## Product Change Notice (PCN)

**Subject:** Change in Marking Format on Humidity Sensor HS3000 series

**Publication Date:** 4/25/2024

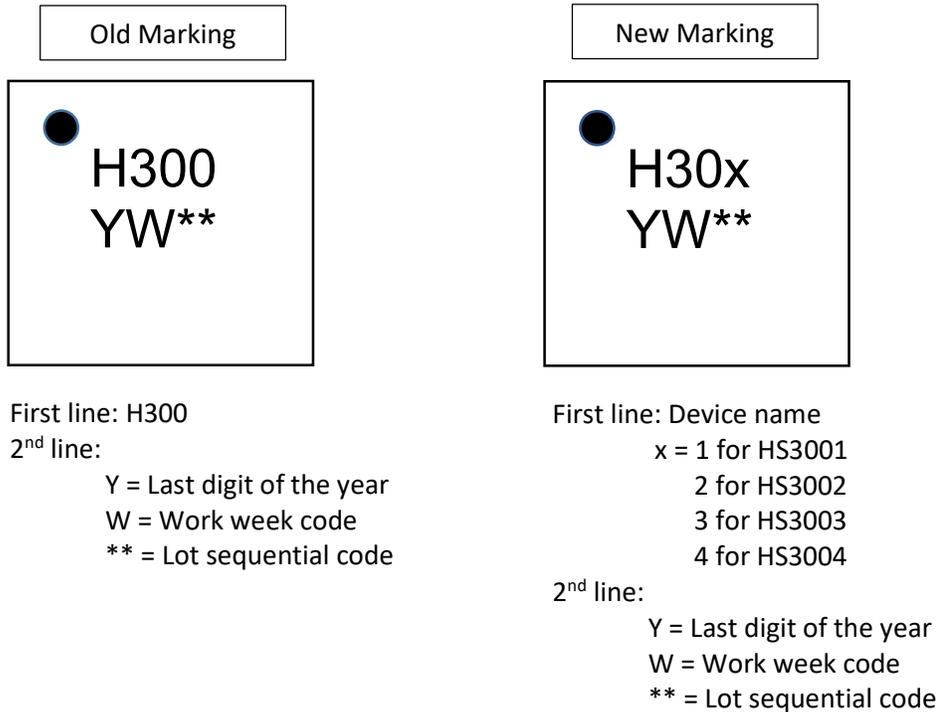
Renesas is changing the marking format on the first line as shown in the below diagram. There will be no change to form, fit, function, reliability and quality of the product.
